BELLEFONTE COMBINED LICENSE APPLICATION – RESPONSE TO
ENVIRONMENTAL REPORT REQUEST FOR ADDITIONAL INFORMATION – CORMIX-
RELATED HYDROLOGY INFORMATION

Responses to Environmental Report Requests for Additional Information –
CORMIX-Related Hydrology Information

NRC RAI NUMBER: 5.2-5, 5.3-3(2), 5.3-3(3), 5.3-5, and 5.3-8

ATTACHMENT 5.3-3(1)A

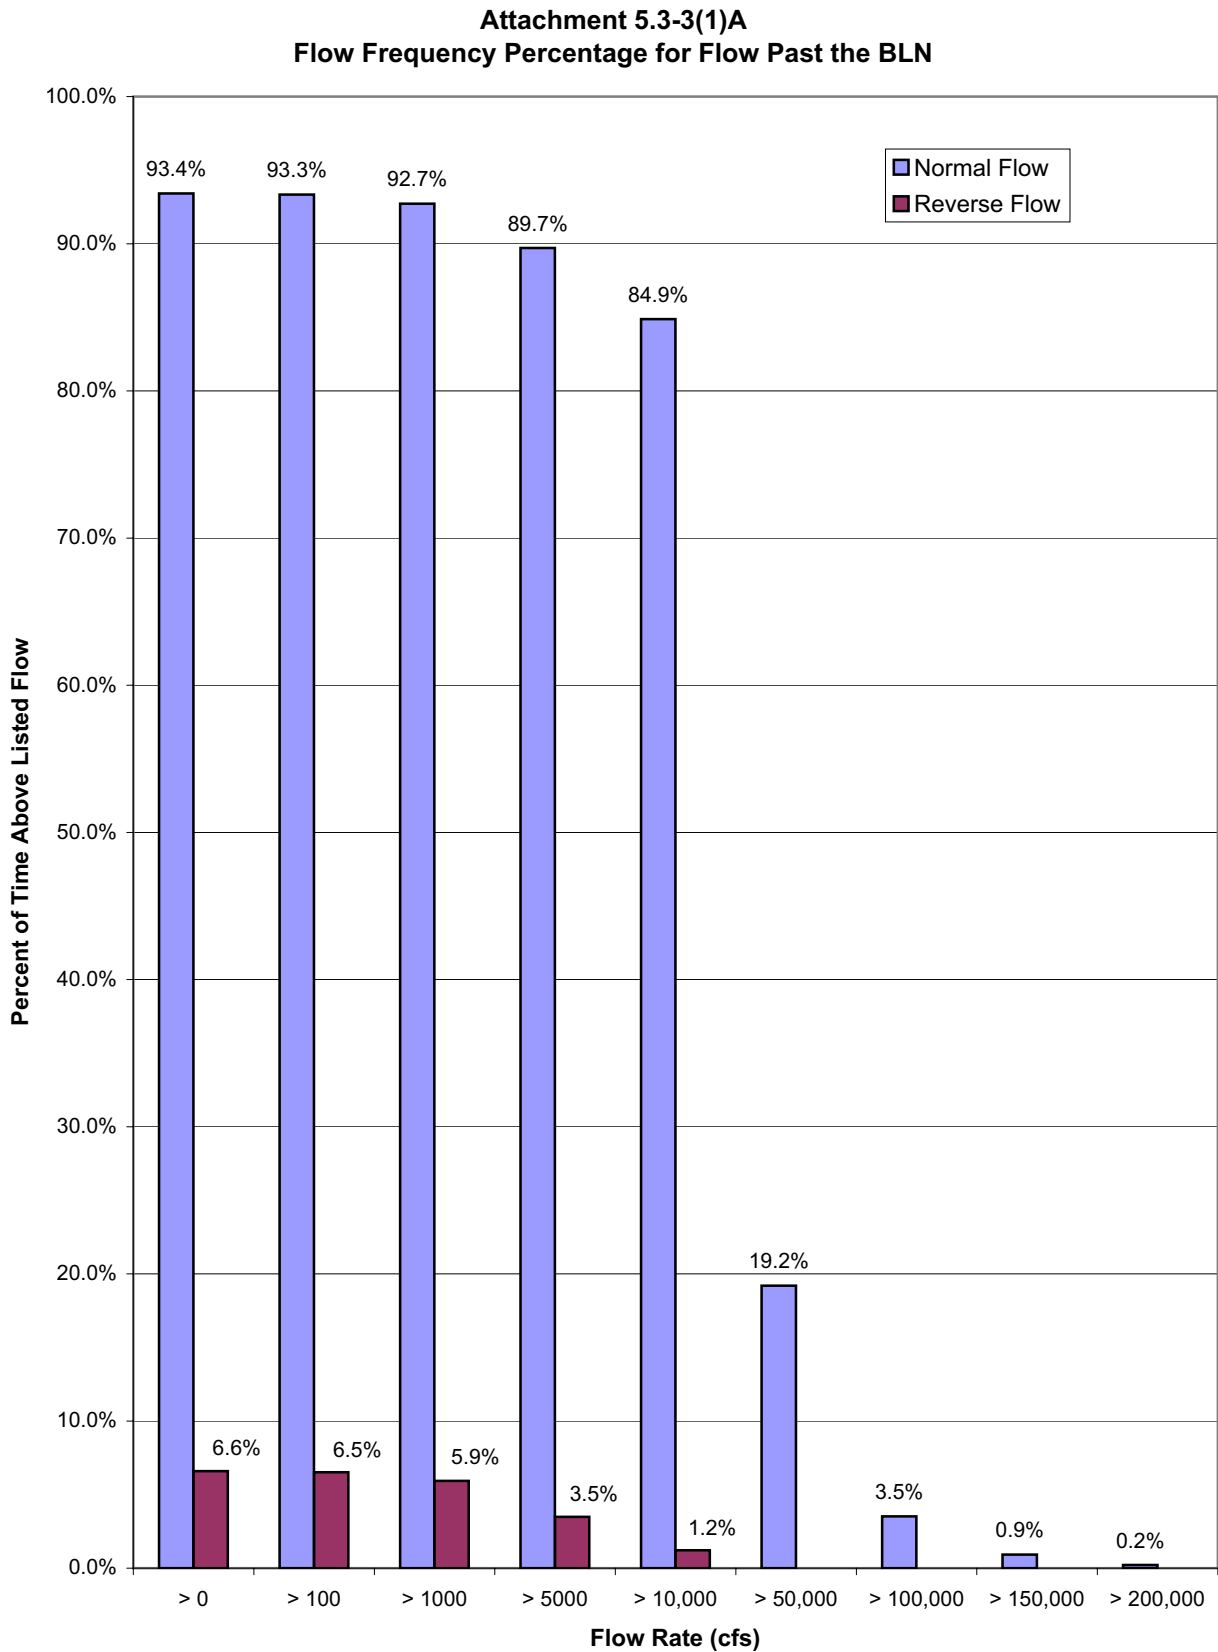
The percentage of time exceeding specific flow rates is shown in Attachment 5.3-3(1)A. Normal river flow direction was shown to occur approximately 93 percent of the time, with flow exceeding 10,000 cfs (normal) approximately 85 percent of the time. Reverse river flow direction was shown approximately 7 percent of the time, with flow exceeding 1000 cfs (reverse) approximately 6 percent of the time.

Attachment 5.3-3(1)B
Typical BLN Flow Rate Response During Reversal

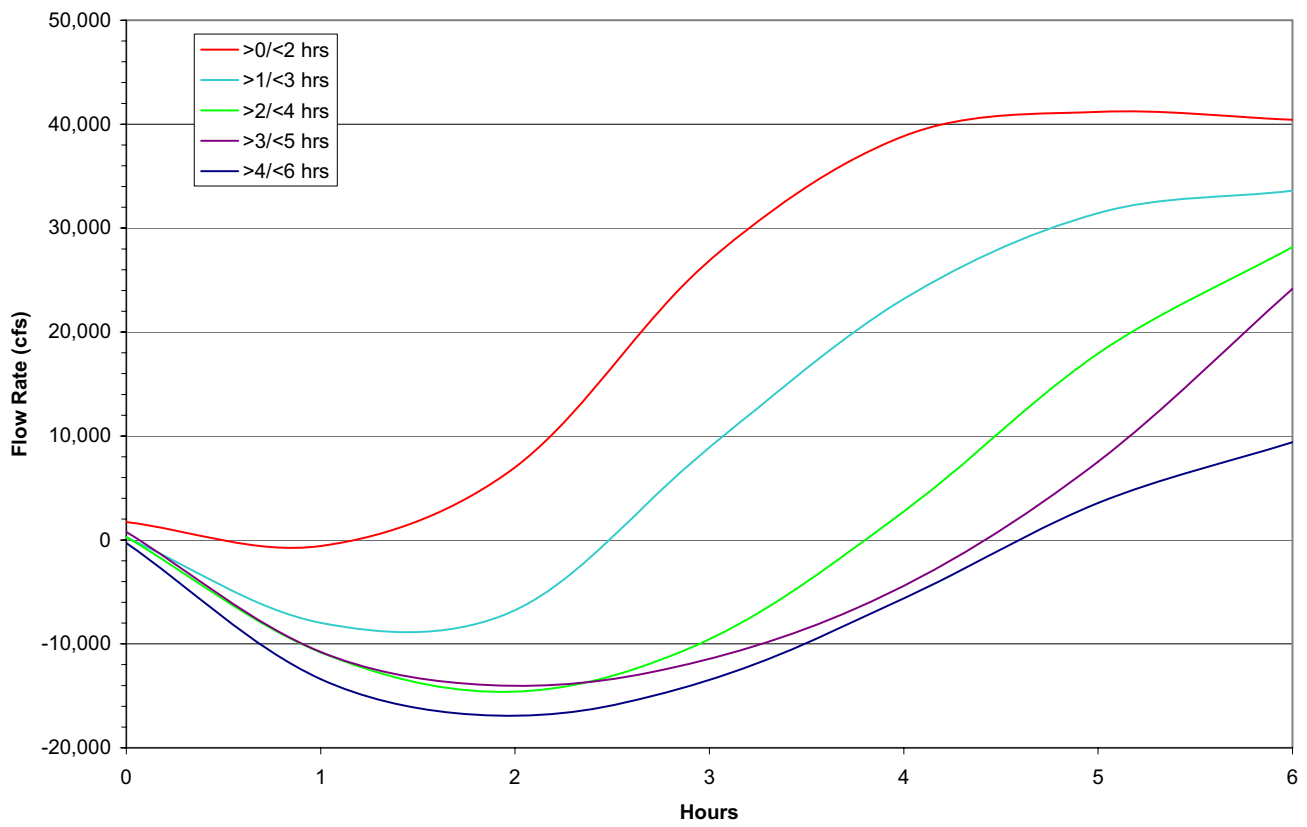
Typical flow reversals were assessed to determine the duration of low-flow conditions associated with the reversal phenomenon. As shown in Attachment 5.3-3(1)B (negative values are reverse flow), a typical flow reversal lasts less than 5 hours. From January 1, 1978 to December 31, 2007, 5025 reversals have occurred. The majority of the reversals (41 percent) lasted between 3 and 5 hours in duration (Attachment 5.3-3(1)C).

Attachment 5.3-3(1)E
BLN Flow Rate Response (June 29-30, 2002)
Compared to Guntersville and Nickajack Dam Releases

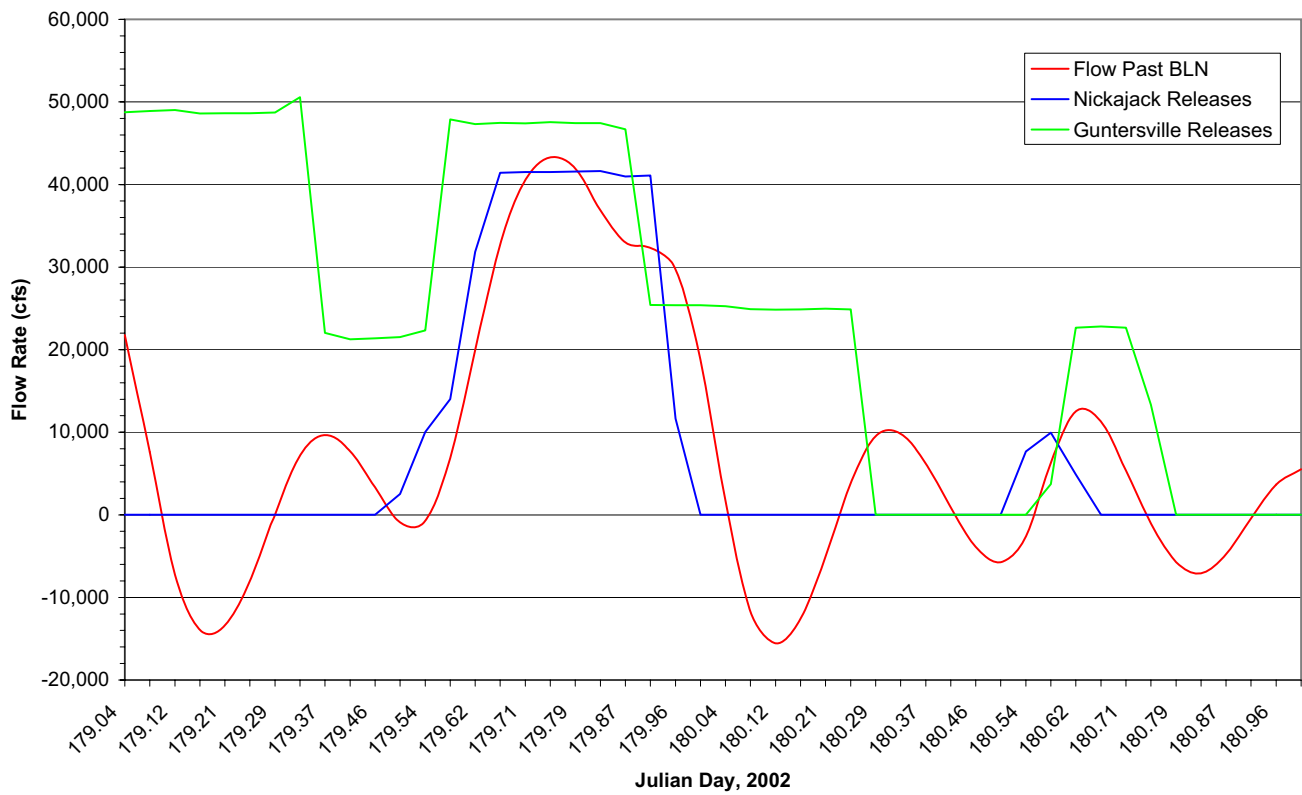
Lower flow conditions (less than 1000 cfs, normal or reverse) during the flow reversals are transient and last only a few minutes as the reversal is taking place (the flow value of 1000 cfs was used for ease of interpretation and as a conservative flow rate). The longest duration of lower flows occurs during the shorter duration (less than 1 hour) flow reversals. As depicted in Attachment 5.3-3(1)D (Attachment 5.3-3(1)B is limited to 1000 cfs), longer duration reverse flow occurrences result in lower flow conditions of only a few minutes as the reversal occurs, with short duration reverse flow occurrences (for less than 1000 cfs reverse flow) producing the maximum lower flow durations (approximately 1 hour at less than 1000 cfs flow, normal or reverse). Based on this analysis, very low flows (less than 100 cfs, normal or reverse), would occur only for several minutes during the flow reversal events with only transient zero flow occurrences. The minimum average daily flow depicted for the Tennessee River at the BLN is 23 cfs, which occurred on June 30, 2002. Although the average flow was 23 cfs on this date, hourly flows for June 30, 2002, ranged between 12,508 cfs normal flow and 15,534 reverse flow, with only momentary flows below 100 cfs as flow direction changed. This relationship is shown in Attachment 5.3-3(1)E, Julian date 180 on the graph.

Typical flow reversal scenarios were graphically compared to show the relationship of flow past the BLN site to the Nickajack and Guntersville Dam releases. Typical flow relationship curves are shown in Attachments 5.3-3(1)E through 5.3-3(1)L for various 2-day periods within the data set. Attachment 5.3-3(1)G depicts the flow relationship curves for the maximum flow reversal occurrence on August 16, 1988, and Attachment 5.3-3(1)I depicts the flow relationship curves for the maximum flow reversal occurrence since 2004 (change in reservoir operations) on June 21, 2006.

Attachment 5.3-3(1)F
BLN Flow Rate Response (May 2-3, 1983)
Compared to Guntersville and Nickajack Dam Releases

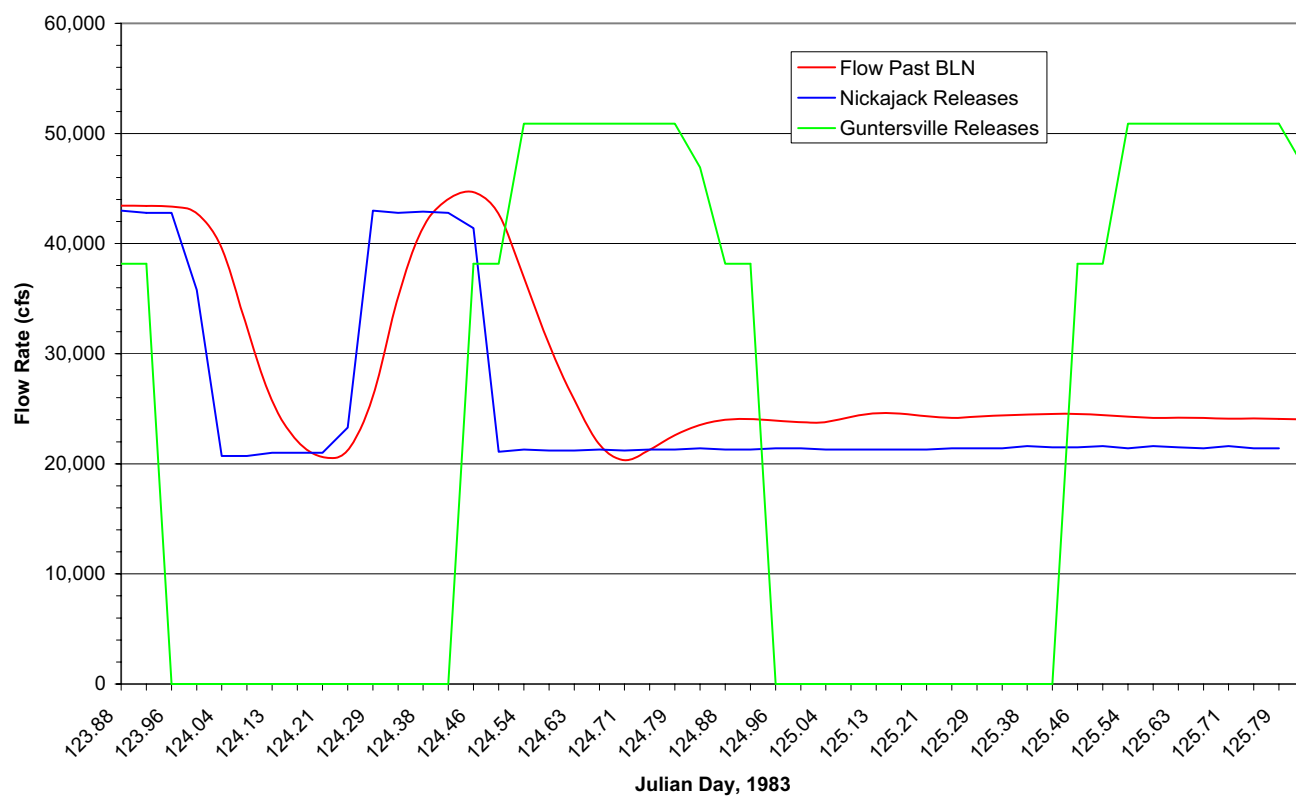
In general, flow past the BLN site seems to be most influenced by the releases from Nickajack Dam. Discharges from Guntersville Dam seem to have minimal effect on the flow rate past the BLN [Attachments 5.3-3(1)F and 5.3-3(1)H]. These curves show the flow reversals are generally a response to lowering or cessation of flow from Nickajack Dam and tend to show an oscillatory response during longer periods of zero dam discharges [Attachments 5.3-3(1)E and 5.3-3(1)I]. None of the oscillations produced extended periods of low flow, even during times where neither dam was discharging.
